Please give careful consideration before increasing the TEU limit to 500,000

Paul van den Bos
18-06-2019

I-14 Intersection of M5 Motorway and Hume Highway

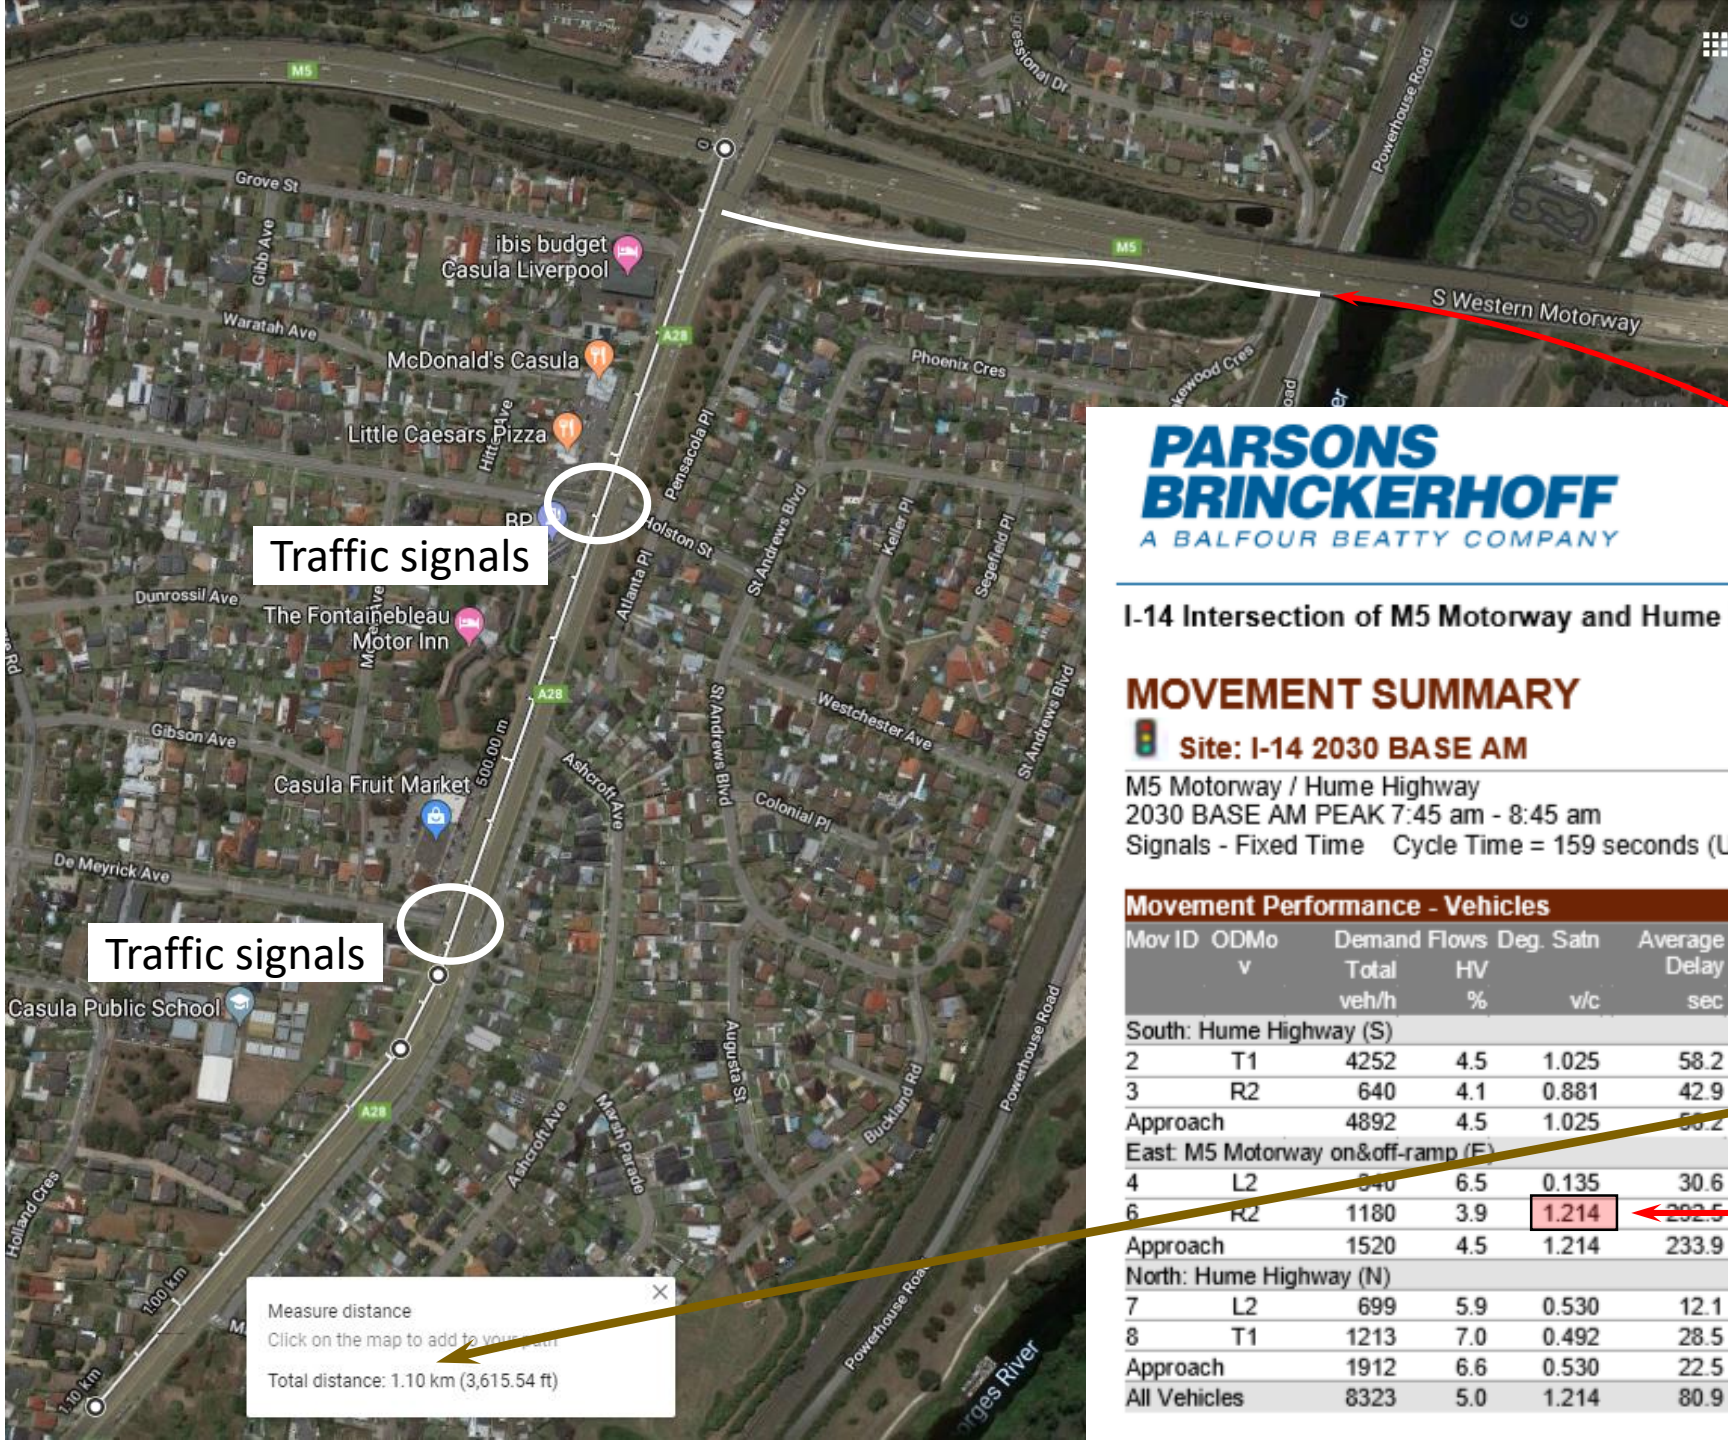
Page 20 - this is that blocked intersection

Below Parsons Brinckerhoff logo – **Intersection of M5 Motorway and Hume Highway**

Same routine – Brown box = 1100.9 m queue length

Plot queue length on Google maps – distance = 1.10 km

Notice – that this queue – blocks – Graham Av – and – De Meyrick Av – traffic lights

Red box with the number 469.4

It has a red arrow – pointing to the queue – on the Hume Highway on-ramp

same row – on the left – the red shaded box – with the number 1.214

Its column title: **Degree of Saturation**

same row – on the right – the Purple box – with 1.43

its column title: **Effective Stop Rate per vehicle**

On average – every right turning vehicle – must stop 1.4 times

About 25% – of the heavily loaded Intermodal trucks – turn right here – see Pages 49 and 50

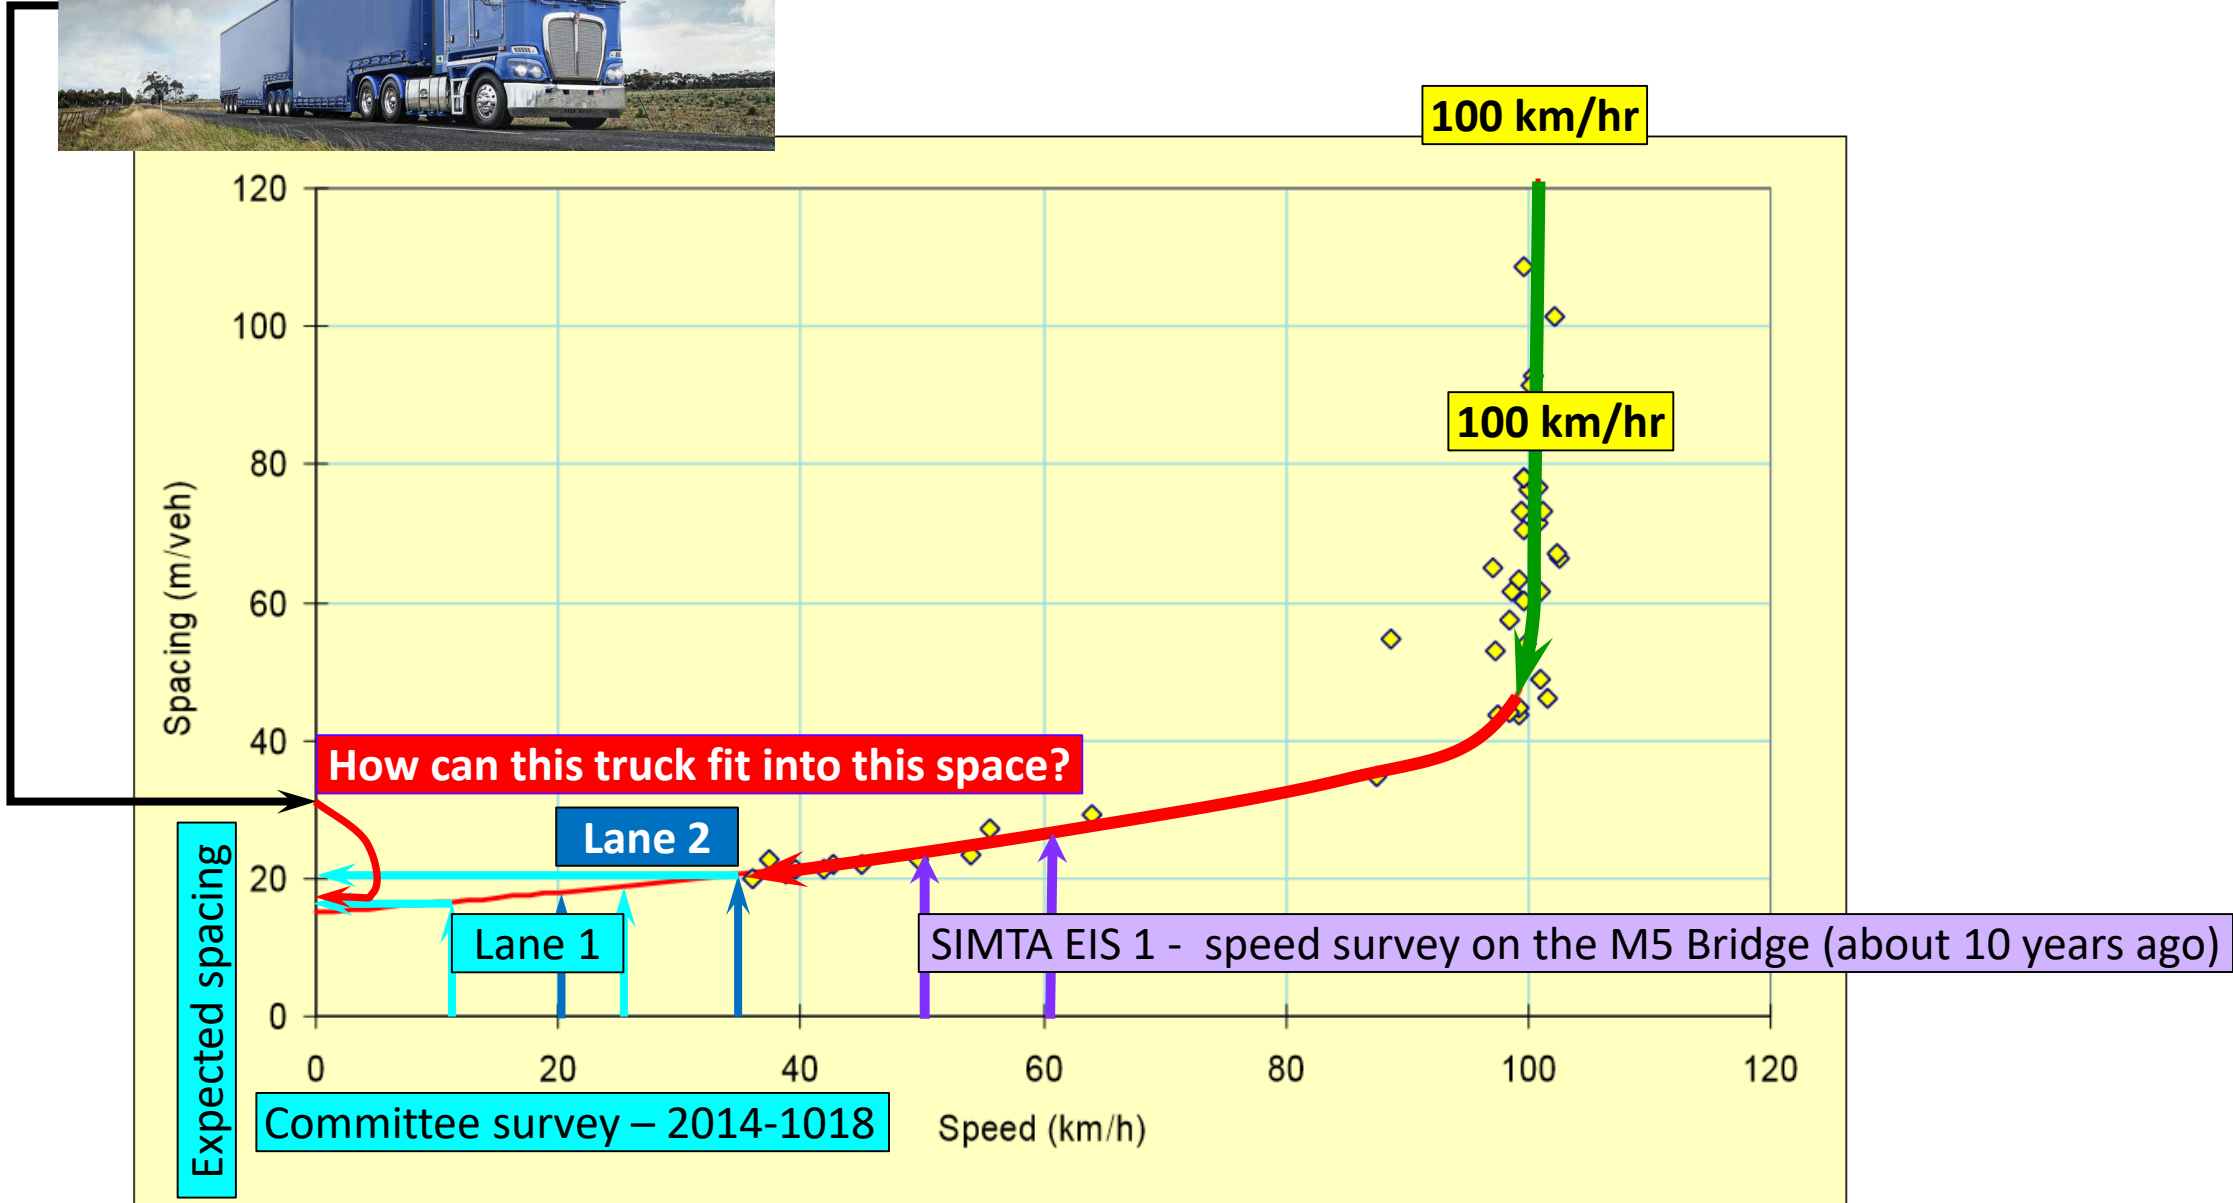
Page 26 shows the – SIMTA EIS 1 – surveyed speed – on the M5 Bridge (about 10 years old)
And the speeds – collected by members – from our community – see Pages 43 to 46

Blue Arrows point to the expected spacing – between vehicles

Length of a B-triple is also shown
(this is the preferred mode of transport – for Moorebank Intermodal)

How can a large truck – fit into a small space – safely – and – at speed

In addition – from the intersection analysis on Page 20
– with the queue – spilling far – onto the M5 Bridge – the distance – for lane changing – is short

I-08 Intersection of Moorebank Avenue and Industry Park Access

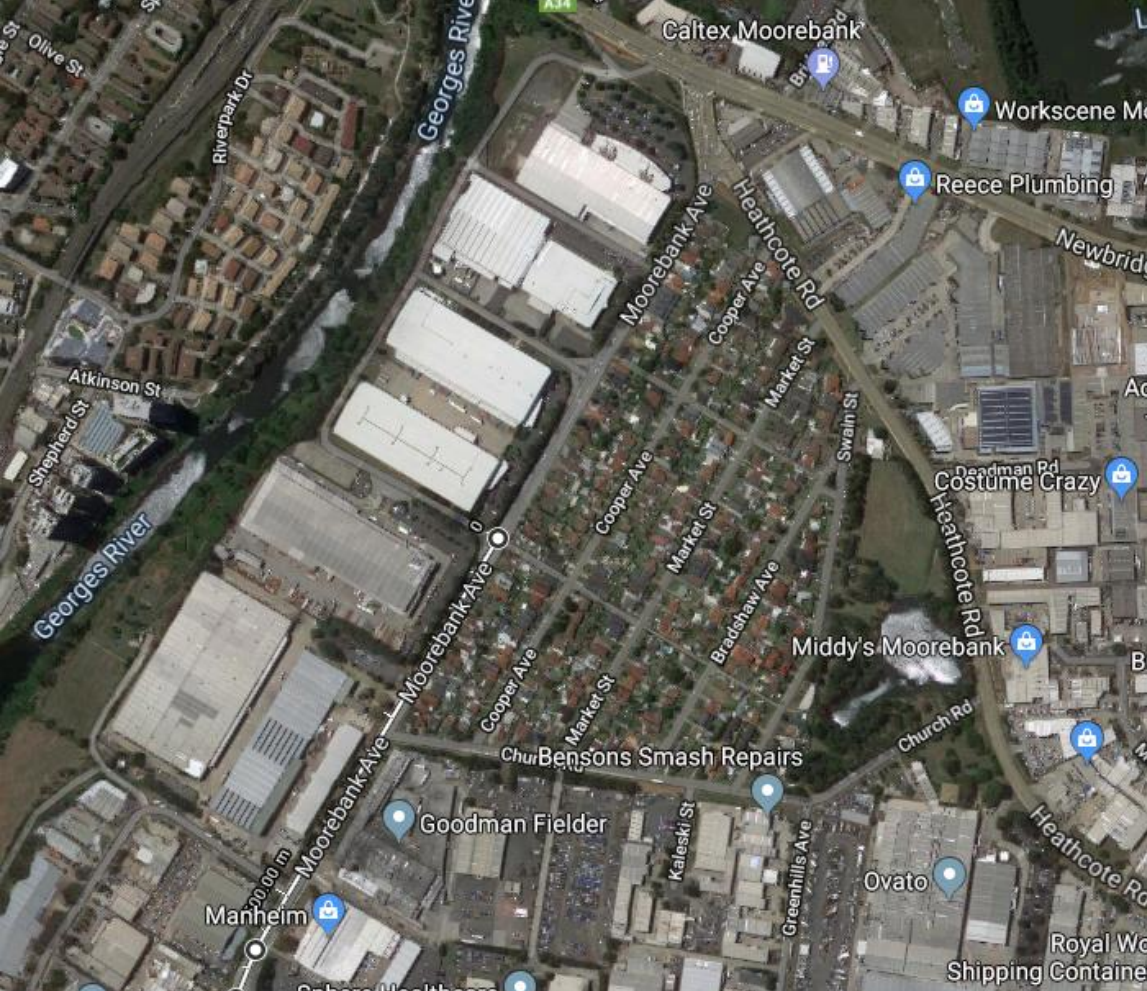
Page 62 show the expected queue length from the Industry Park Access on Moorebank Av plotted on a Google map. This is the Base AM – no Moorebank Intermodal traffic

The queue length is much longer than the distance between the intersections

As before, in the other examples, this existing queue is ignored when the Moorebank Av – M5 intersection was modelled

The purple box – there is a number highlighted in Yellow + a Red annotation!!!

Not all of the demand travelling southbound (810) can travel through this intersection

In fact, only 635 vehicles can travel through this intersections

Where in the network will this difference in car numbers be stored (over 1km of bumper-to-bumper vehicles?)

I-09 Intersection of Moorebank Avenue and Church Road

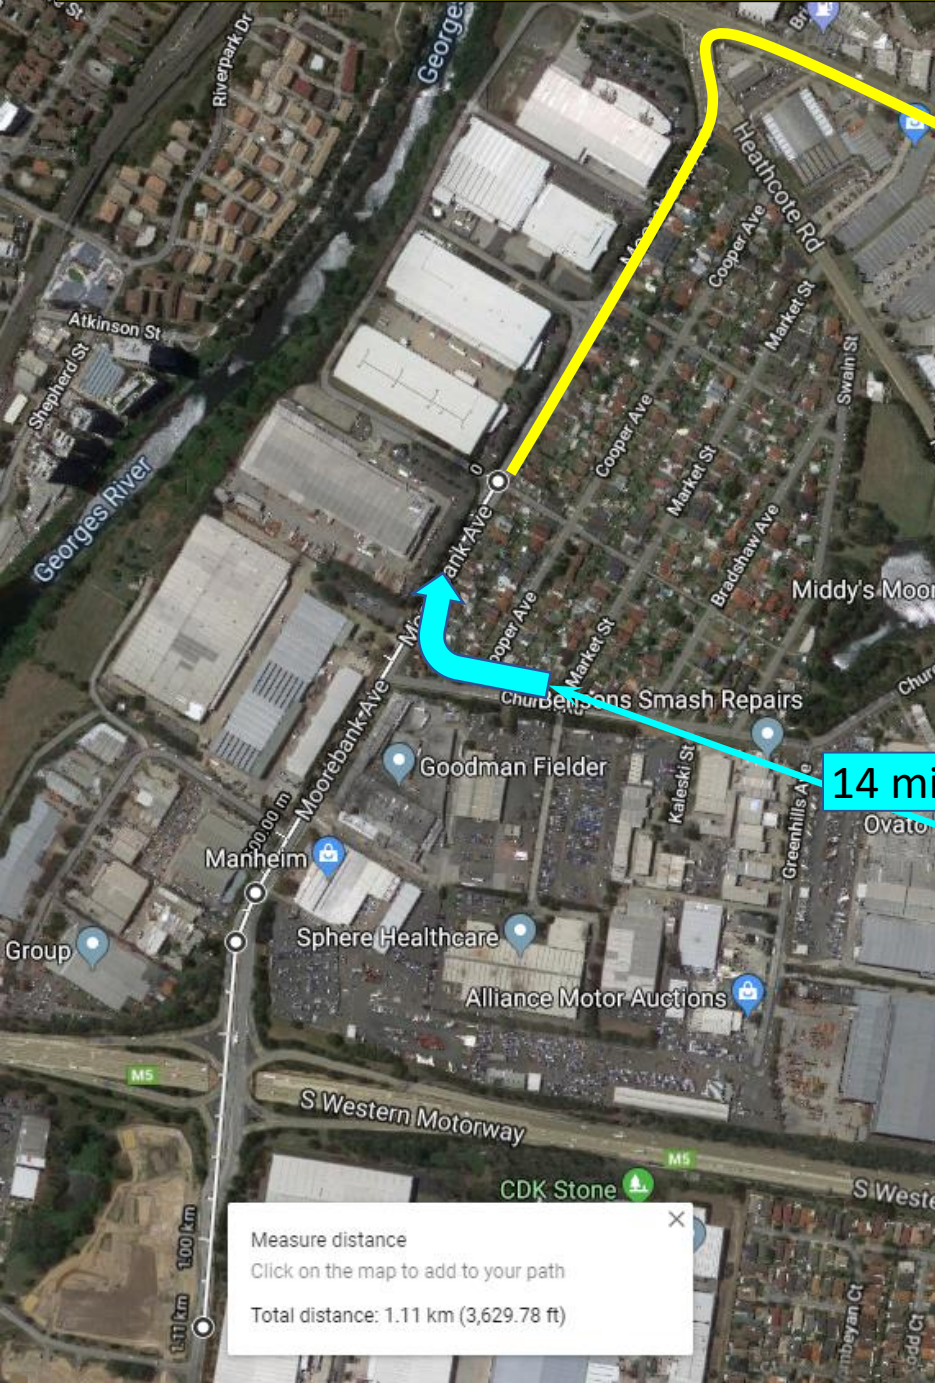
The MICL EIS modelling it takes 14 minutes 5.2 seconds to make this right hand turn
